**RESPONSE TO REVIEW AND
SUPPLEMENTAL RECOMMENDATIONS**

FOREST GREEN ESTATES
Wesley Way and La Crescenta Road
Richmond, California

Project No. 7707.G
3 August, 2005

SUBJECT: Forest Green Estates
Wesley Way and La Crescenta Road
Richmond, California
**RESPONSE TO REVIEW AND SUPPLEMENTAL
RECOMMENDATIONS**

GEOLOGIC SITE PLAN
 SHEET NO. 1
 PROJECT NO. 1777-6
 DATE 10/10/00
 BY J. J. J.

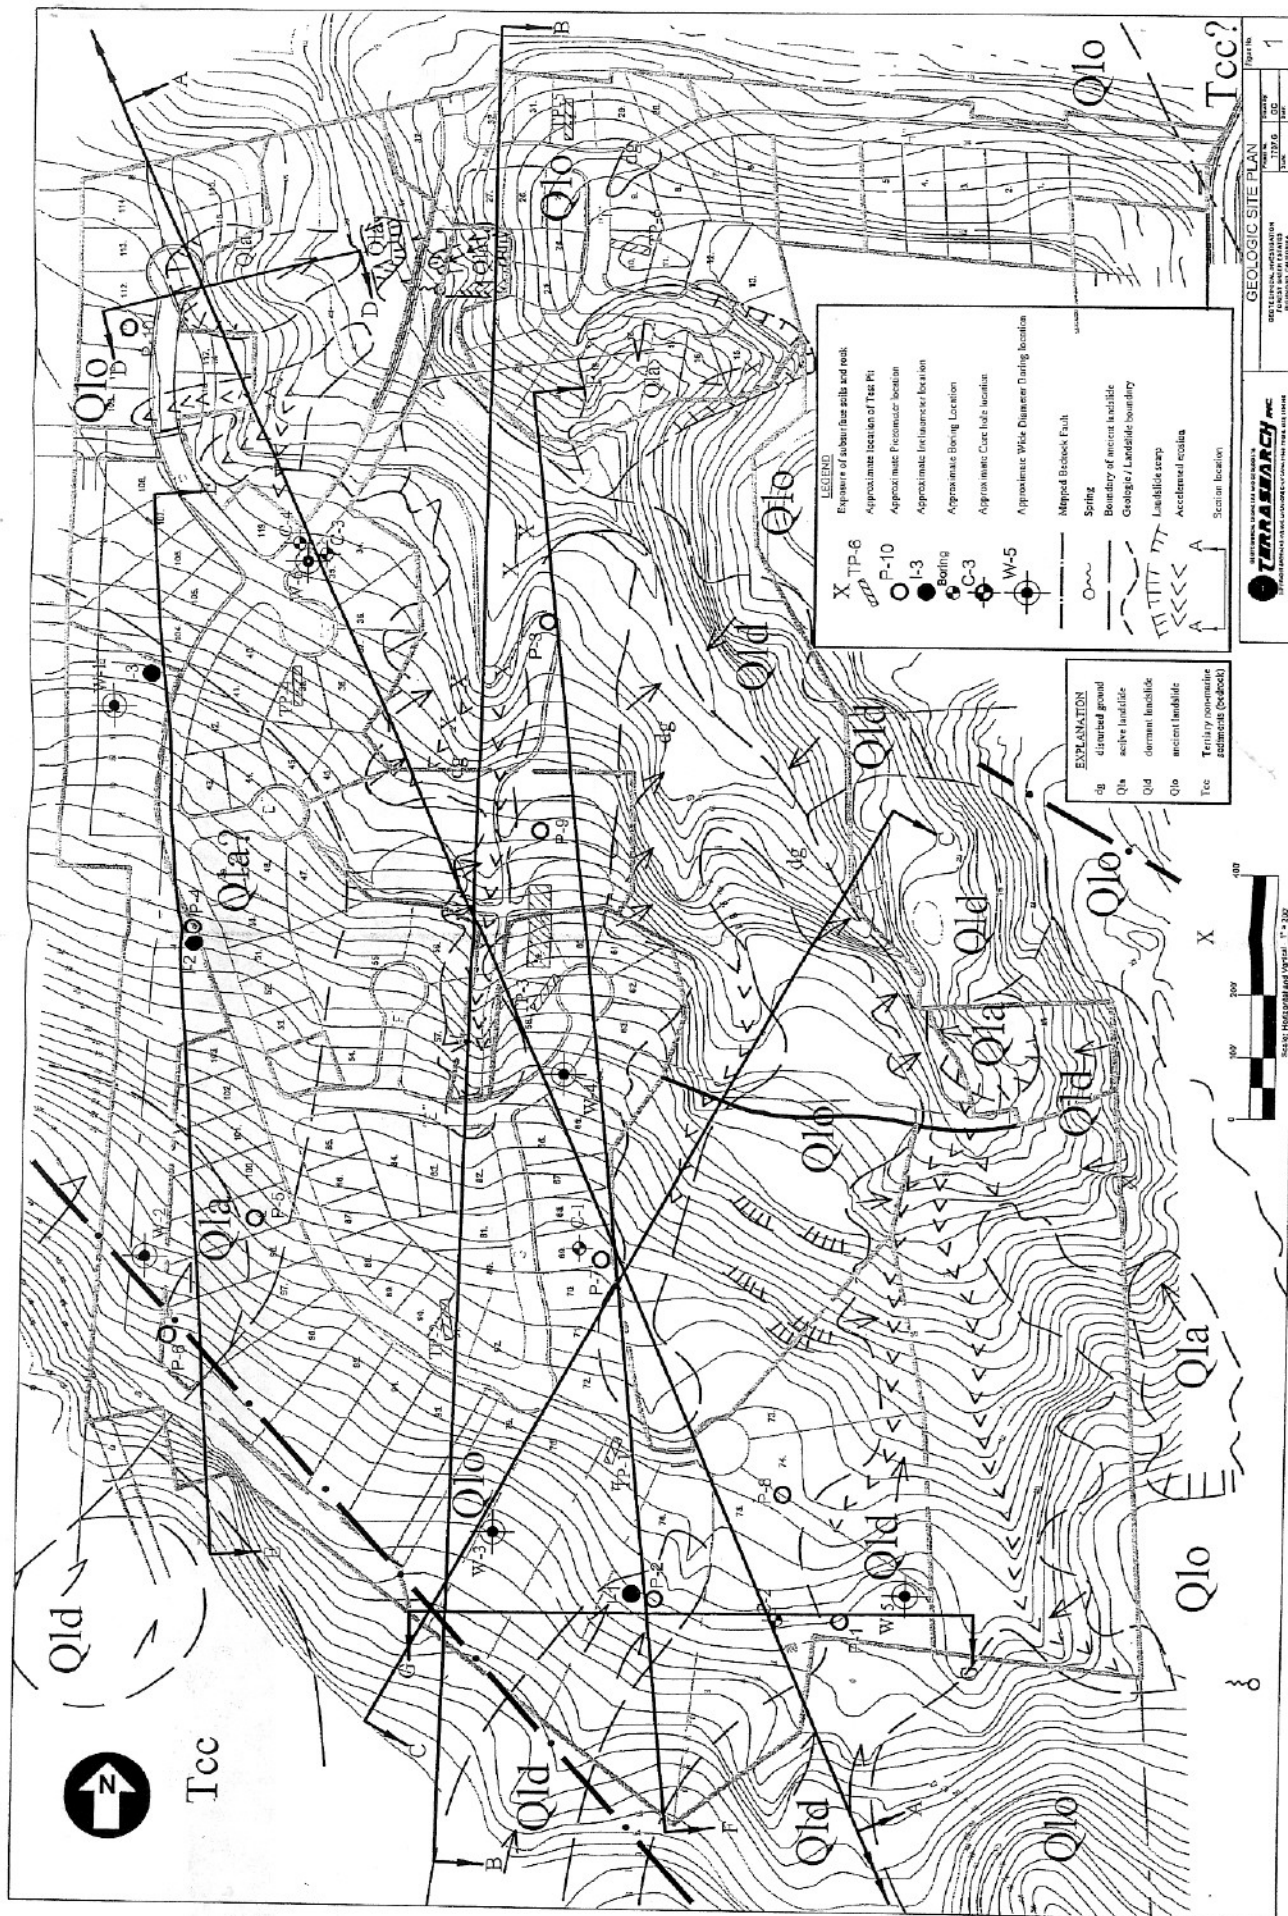
The nested piezometers consisted of three standpipe piezometers in one hole at depths of 40 feet, 80 feet and 120 feet, below current ground surface, at the locations shown on Figure 1, attached. The ground water measurements in the piezometers was monitored over time. The results of the monitoring is presented in the attached Table I. The monitoring data indicates that several zones of perched water exist within the landslide mass. The data suggests that more water is present along the south and west parts of the site than in the center of the site. A regional groundwater

It was initially hypothesized that the difference in groundwater conditions across the site may be influenced by geologic structures such as inactive bedrock faults underlying the site. These inactive bedrock faults have been mapped by Bishop et al (1979) and are shown on Figure 1. The data is not conclusive to support the likelihood that these bedrock faults may be acting as an aquiclude that dams up water behind it, but it is not discounted. The inactive bedrock fault may not have undergone enough displacement to create a clay gouge barrier. In addition, the actual location of the mapped bedrock faults may be different due to the landsliding events.

CROSS SECTIONS EE, FF, & GG

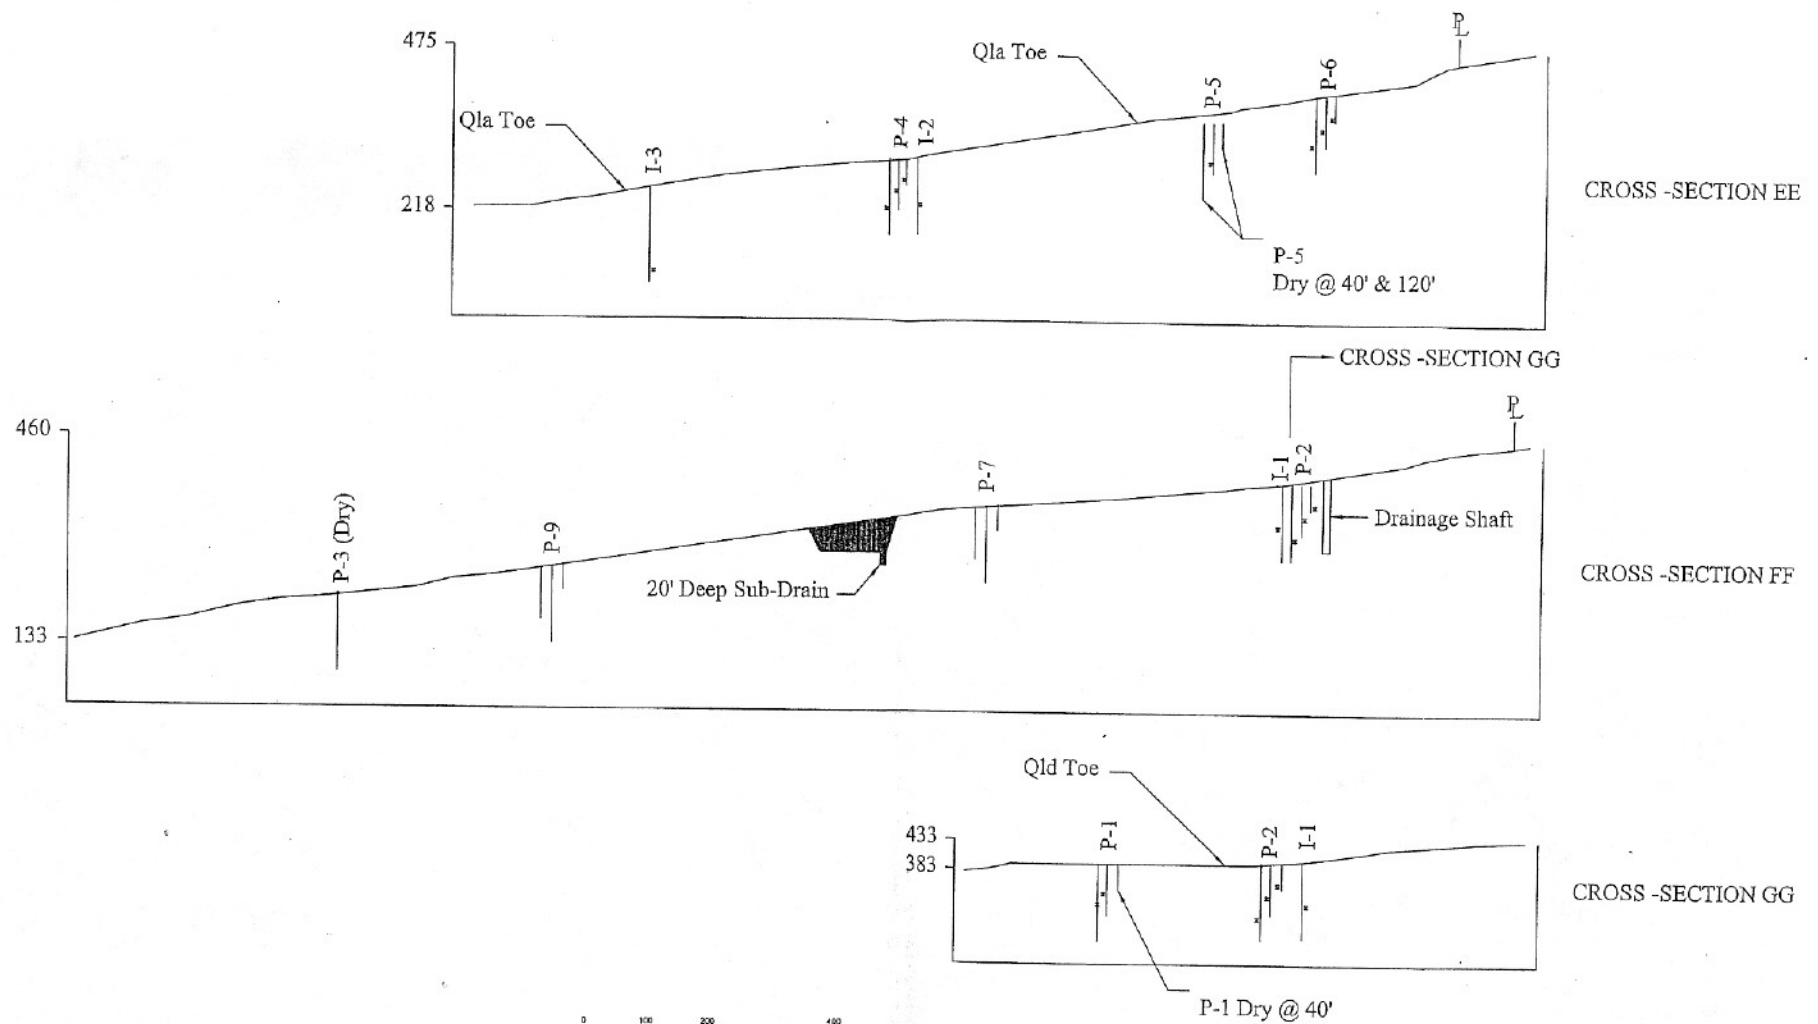
The observed groundwater conditions may be due to water generated from the higher elevation entering the landslide mass within more permeable zones and dissipating through the site. The high piezometric head within the 120 foot stand pipe of P1 may be a result of the piezometer being located within the axis of a broad swale feature. Swale features generally show higher concentrations of groundwater as surface water is channeled rather than sheet flowed. Cross section EE, FF and GG were generated across the site to show groundwater conditions, and are attached as Figure 2.

The implications of a high groundwater table is that it can create low factors of safety against stability. This can be mitigated by draining the water from the ground to a lower level. Drill Tech and Drilling Shoring has proposed to excavate two 25 to 30 foot diameter shafts to a depth of 120 feet, which have a series of horizontal drains radiating out a distance of up to 300 feet from the shaft at various elevations. These two shafts will be located at the southern end of the site, where the groundwater conditions are greater. A plan view of this scheme is shown on Figure 5 Mitigation Plan attached. The water would be collected into the shaft and either pumped out to a surface storm drain facility or gravity drained to an onsite natural swale at the lower levels of the site.

STABILITY ANALYSIS FOR SECTION H-H

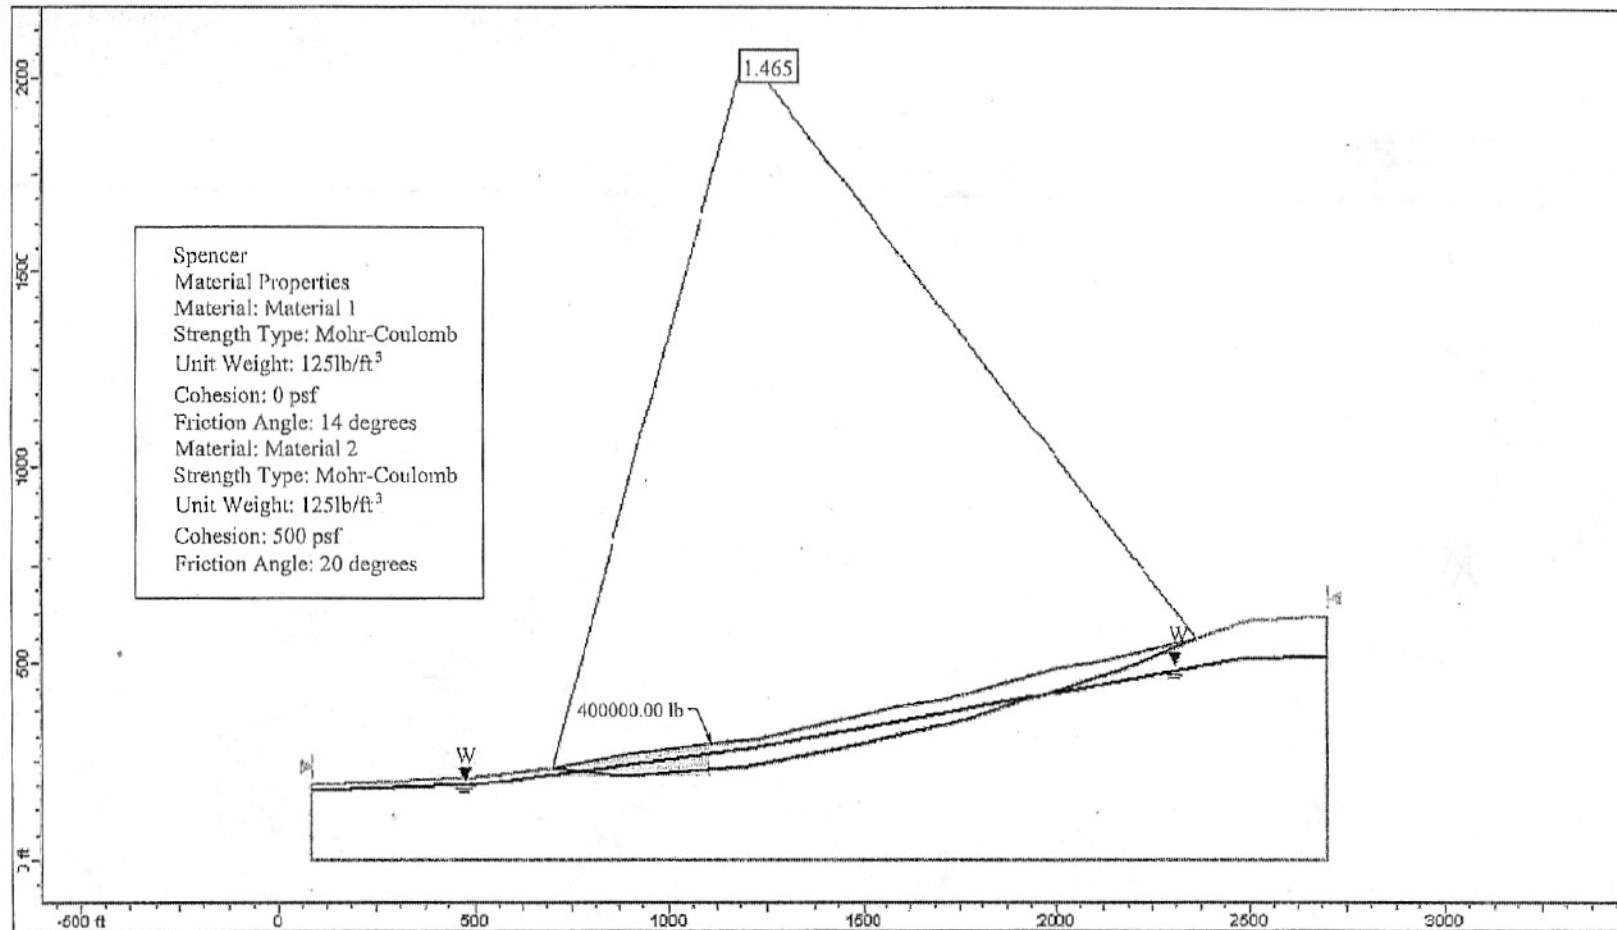
Based on the above results a slope stability analysis was performed on the slide and if a load of 400,000 lbs inclined at 37.5° from the horizontal is applied at the property line jog, the slide factor of safety would be 1.5. The slope stability analysis of the cross section is shown as Figure 4. The piers located along the west property line in a north-south direction (downhill) will only be subjected to 77,000 lbs of normal force inclined at 37.5° from the horizontal. This includes the effects of buttressing that will occur as described below.
